**REPORT ON HEARING  
TOWN OF BEAUSEJOUR  
SEWAGE LAGOON EXPANSION**

**THE CLEAN ENVIRONMENT COMMISSION**

**AUGUST 10, 1989**

**FIGURE 1**

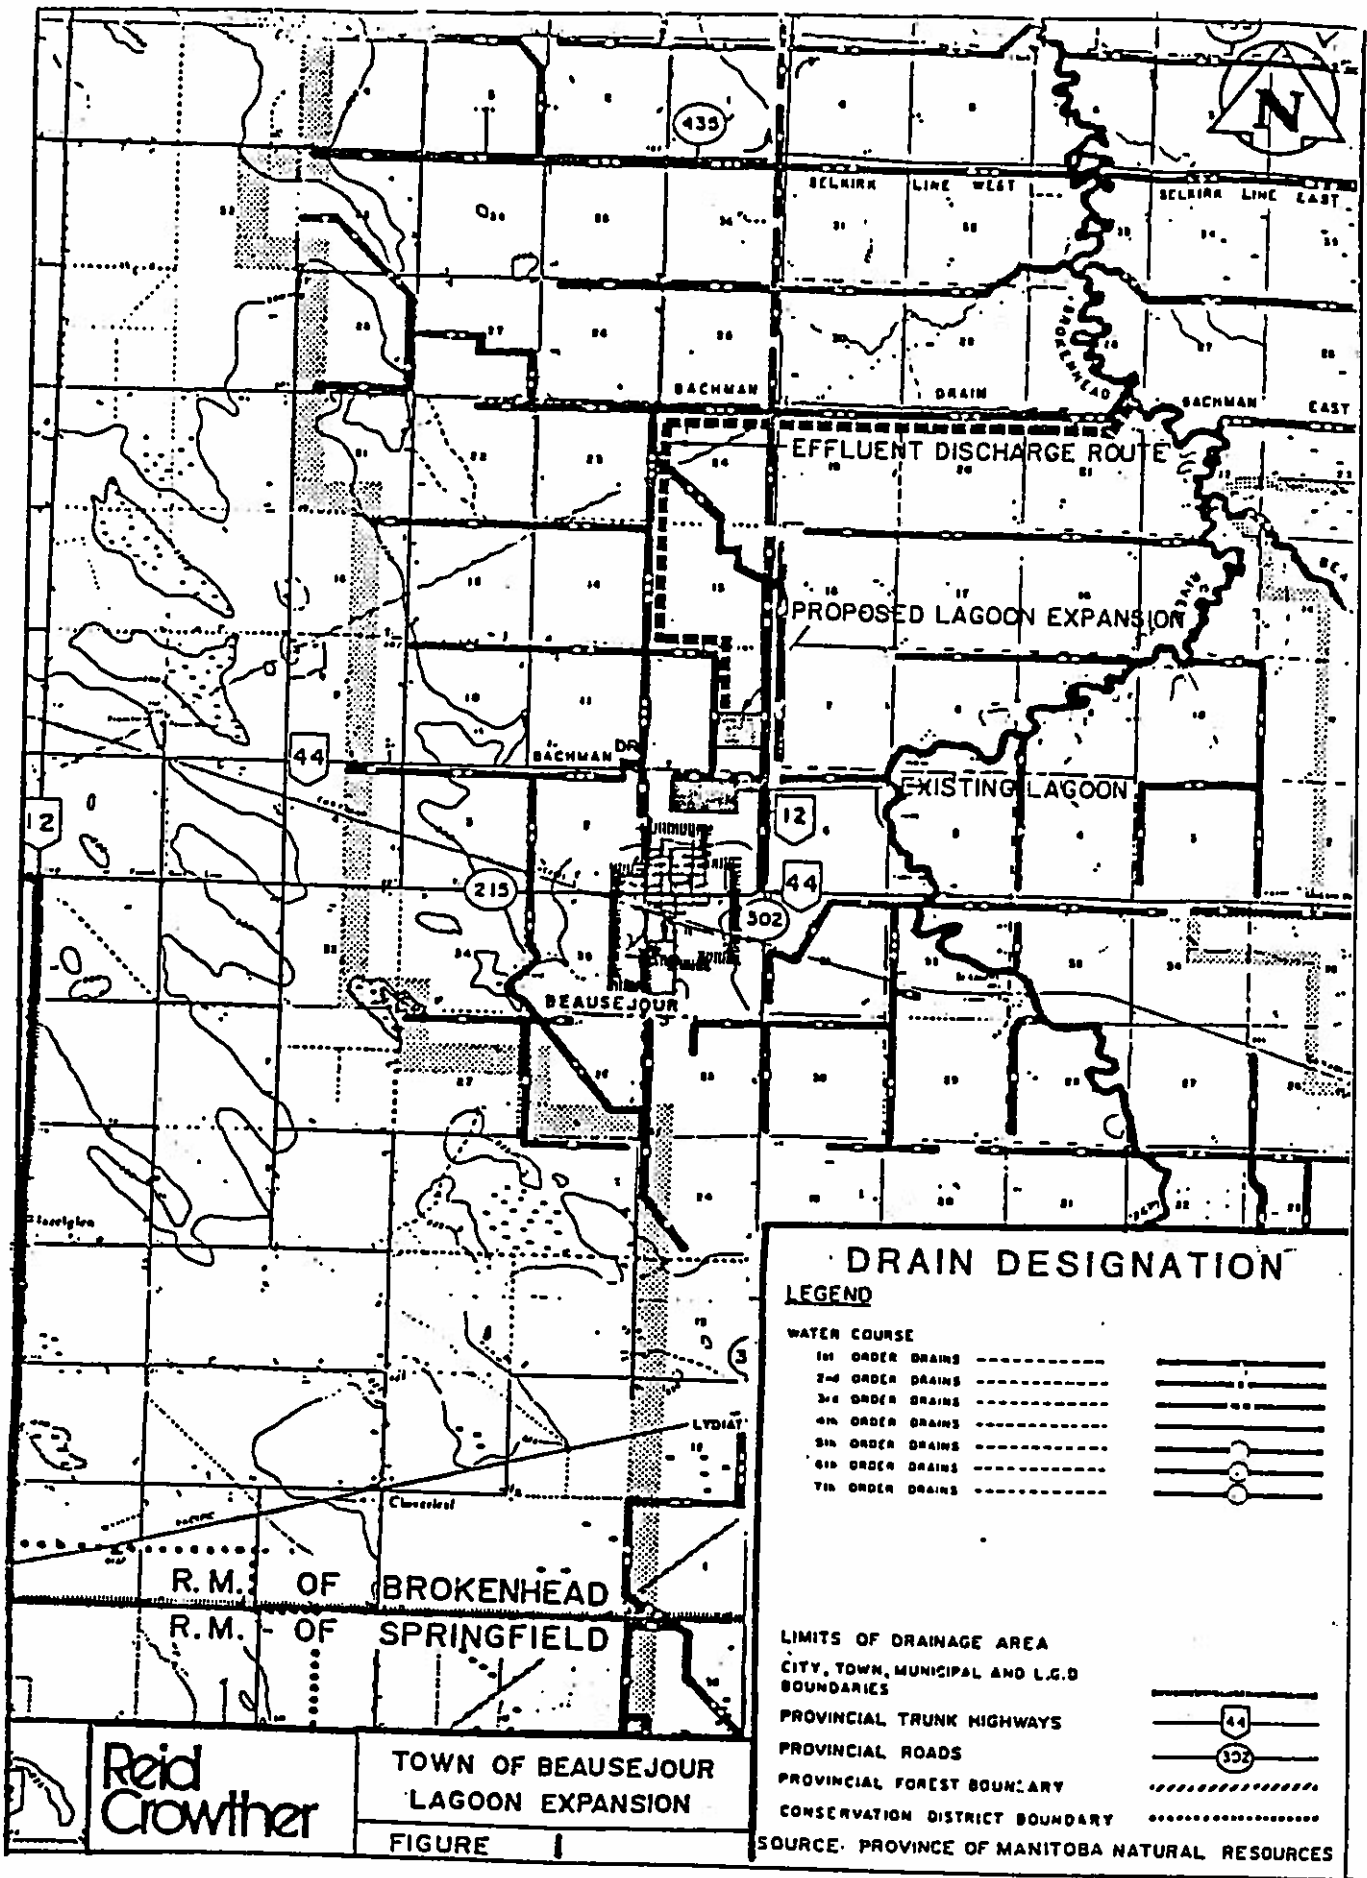
At the hearing, Mayor Mazur noted that the proposal accepted by Town Council was to construct a 6.5 ha (16 a) cell on a site on the north side of PTH 44, north of the present cell #5 (figure 1) This site is located on SE 1/4 12. 13. 7. The present drainage route would continue to be used for effluent discharge to the Brokenhead River.
